**Change Notification #:** 112684 - 00  
**Change Title:** Intel® Server System R1304BB4DC  
PCN 112684-00, Product Design, Label  
Update System PSU Bracket and Labels  
**Date of Publication:** October 30, 2013

Intel will implement the following changes on Intel® Server System R1304BB4DC:

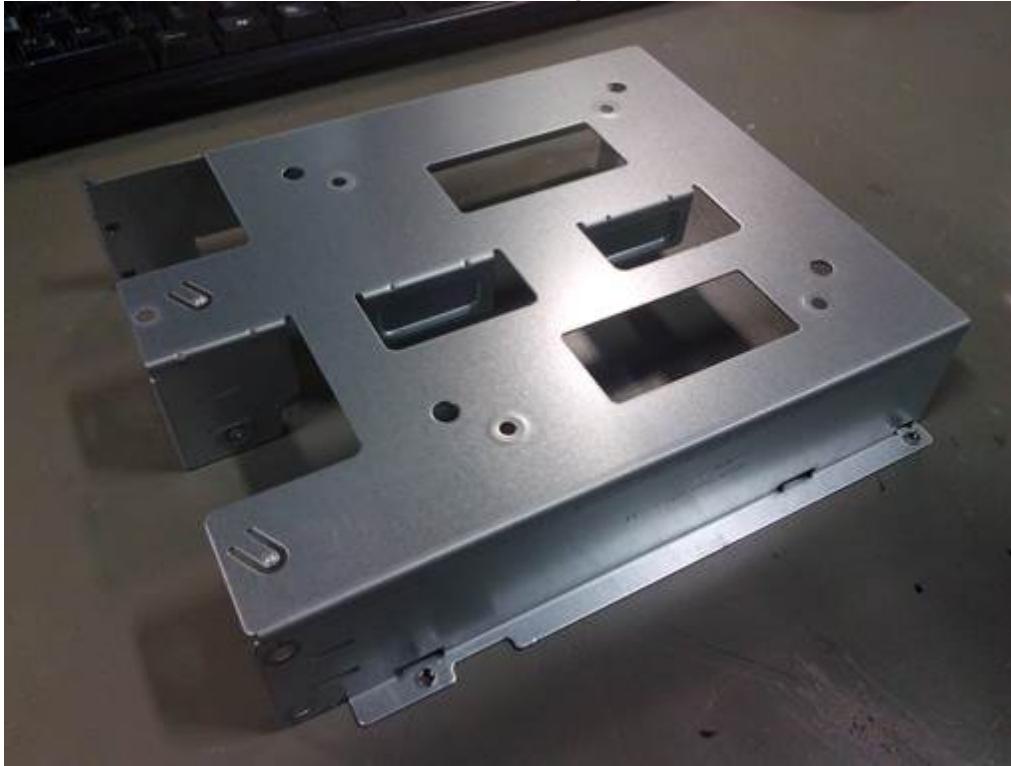
1. Update the Power Supply bracket to remove middle punch. Please refer to below pictures for details:
